REPORT TO CITY PLAN COMMISSION

Item: Preliminary Plat – Fourth Addition to Clearwater Creek

PRELIMINARY PLAT
FOURTH ADDITION TO CLEARWATER CREEK

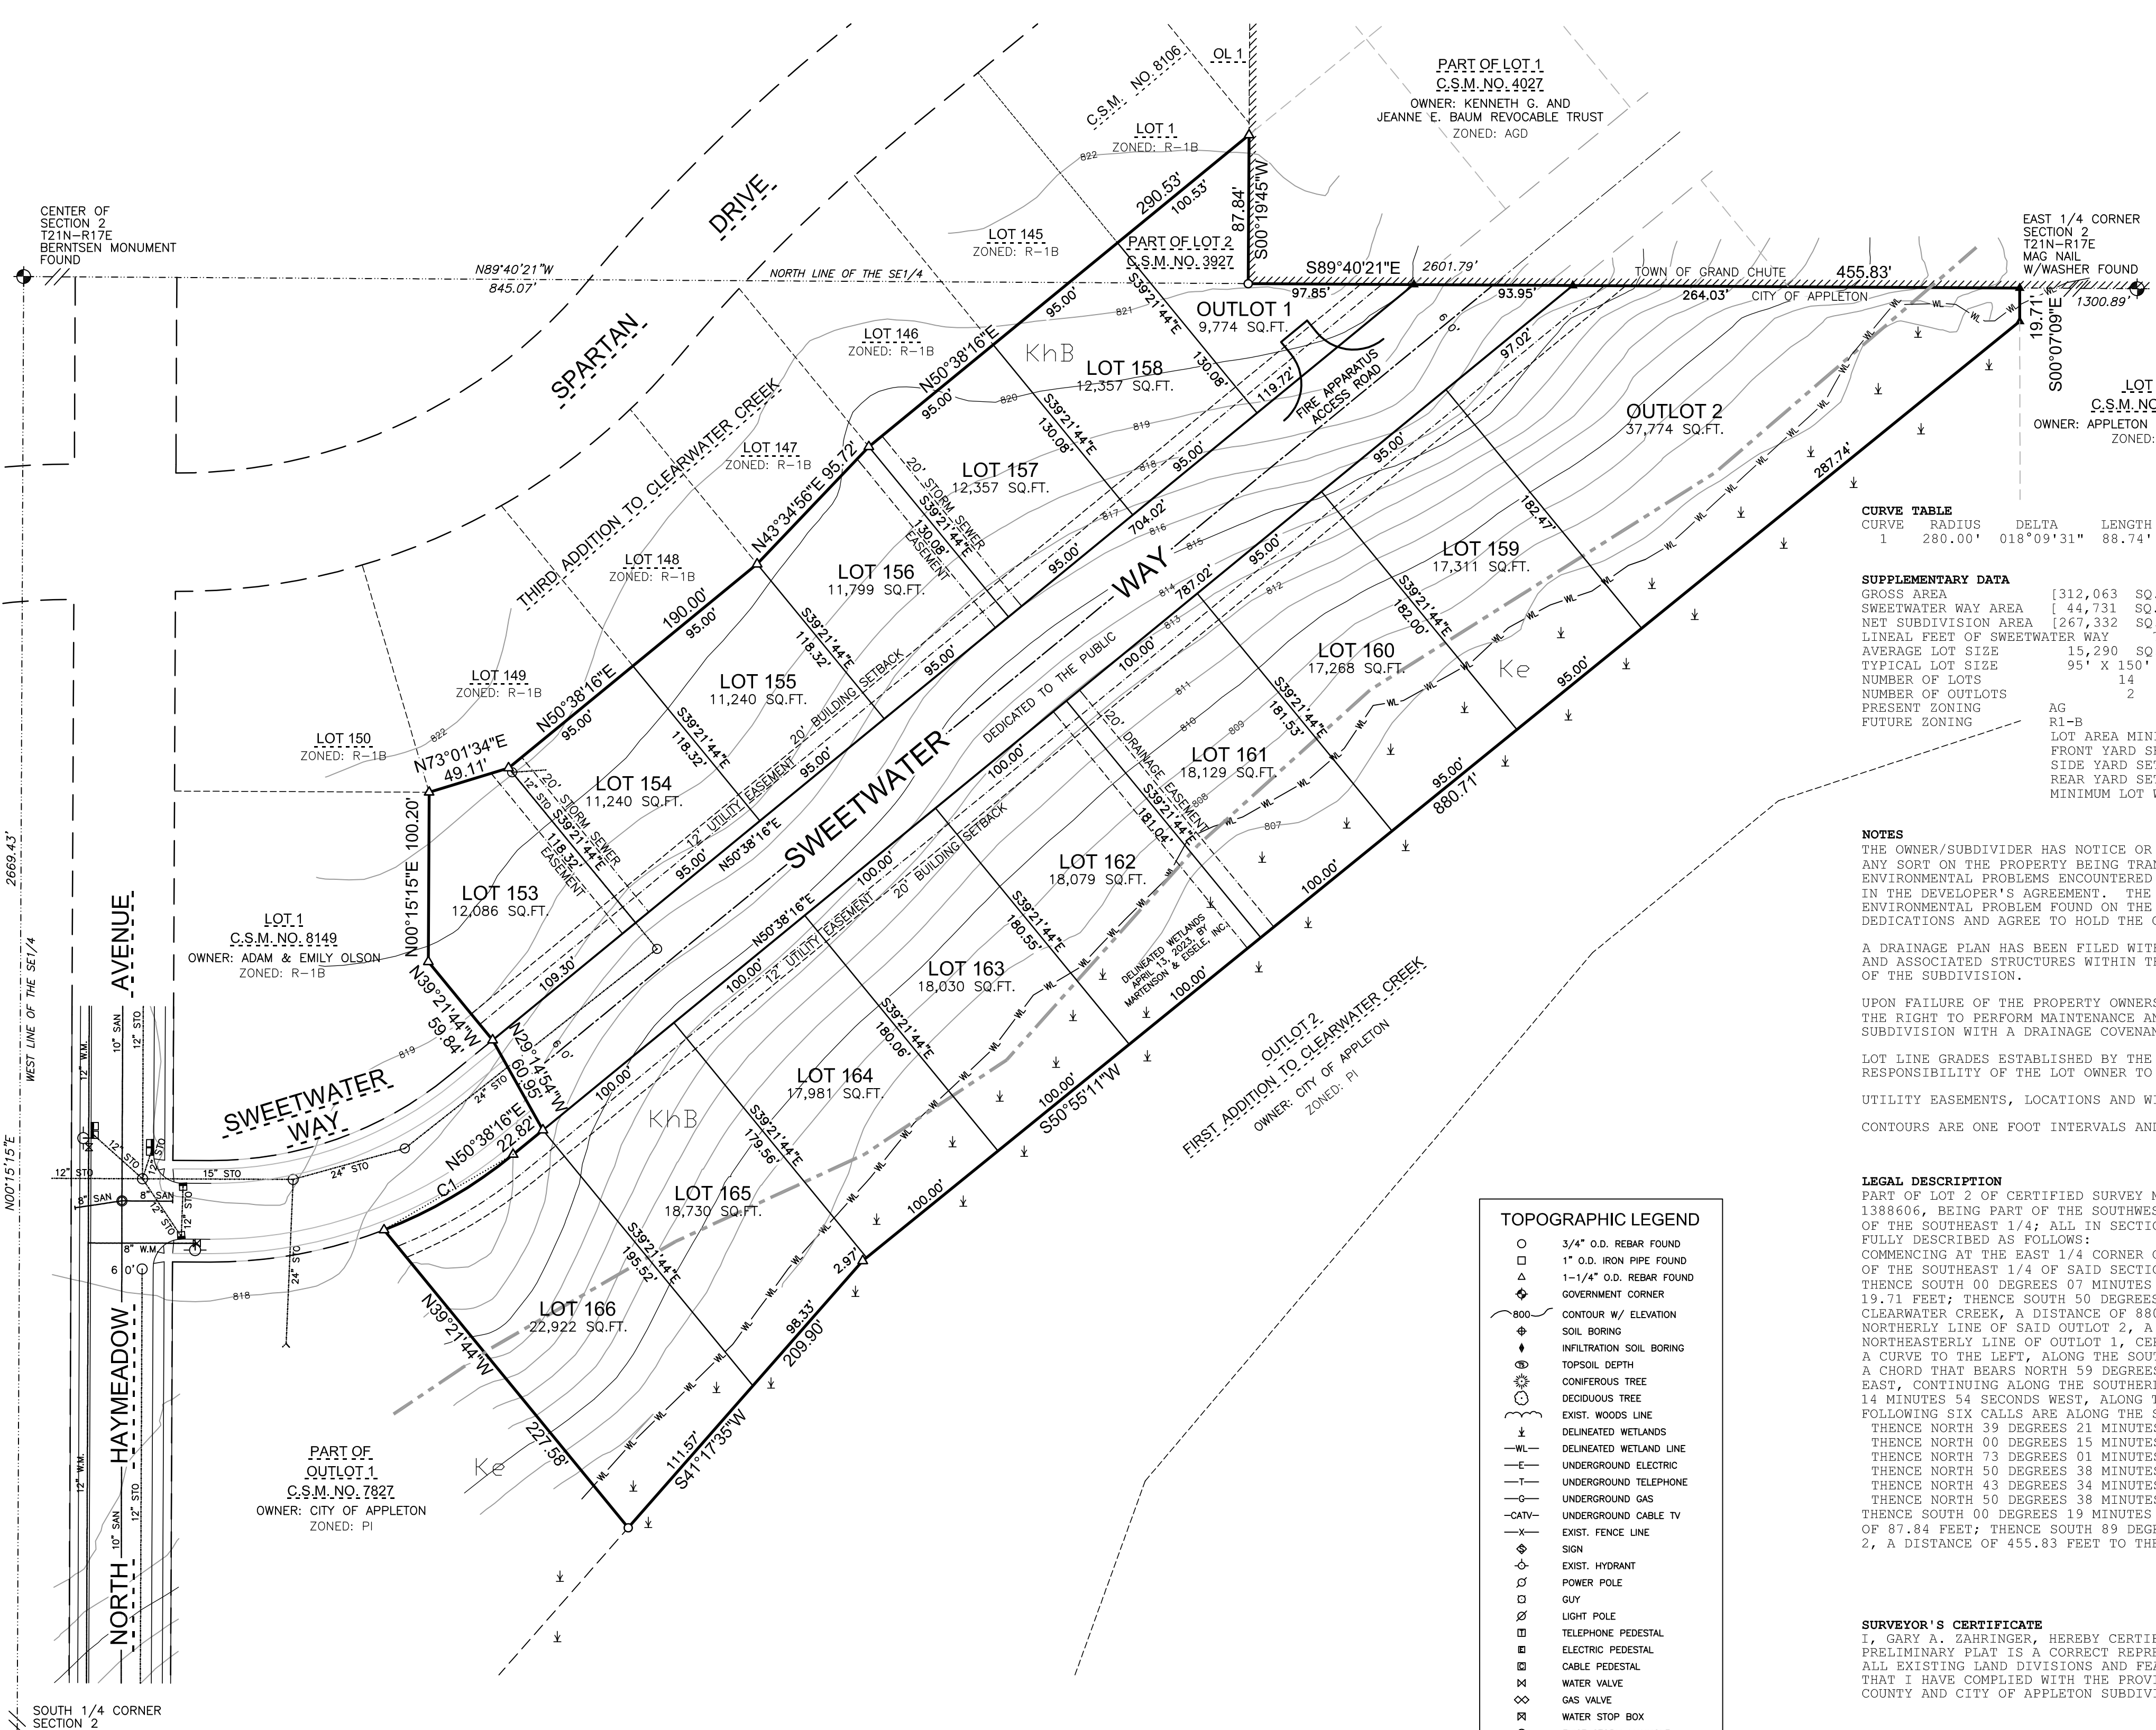
- The drive from Spartan to Richmond would count as a secondary access for the fourth phase of Clearwater Creek. This drive would need to be maintained as such. For the fifth phase of Clearwater Creek, this access will not be acceptable as a secondary access.
- The fire apparatus turnaround at the northern limits of East Sweetwater Way is acceptable as long as it is designed to meet the standards defined in Appendix D from the 2018 IFC. The applicant has been provided with the design standards and has incorporated them into the design as shown on the preliminary plat.

3. Show the extents of the Protective Area per the stormwater management requirement and verify that Lots 160 -162 are buildable.
4. Add the necessary drainage easements per the stormwater management review comments.

5. Show the Normal Water Level and 100-yr Water Level of the stormwater pond.
6. Show the overland flow paths.
7. List the intended purpose/uses for Outlots 1 and 2 on the Final Plat.

8. Hydrant benchmarks should specify the benchmark location on the hydrant, for Waterous type hydrants the “City” location is the “Top shoulder” of the hydrant.

9. The “Fire Apparatus Access Road” shown across a portion of Outlot 1 should have an easement area specified on the Final Plat. One option could be a Temporary Turn Around Easement, with verbiage similar to: Temporary Turn Around Easement, shall be released automatically upon the dedication, construction, acceptance, and Northeasterly extension of Sweetwater Way.
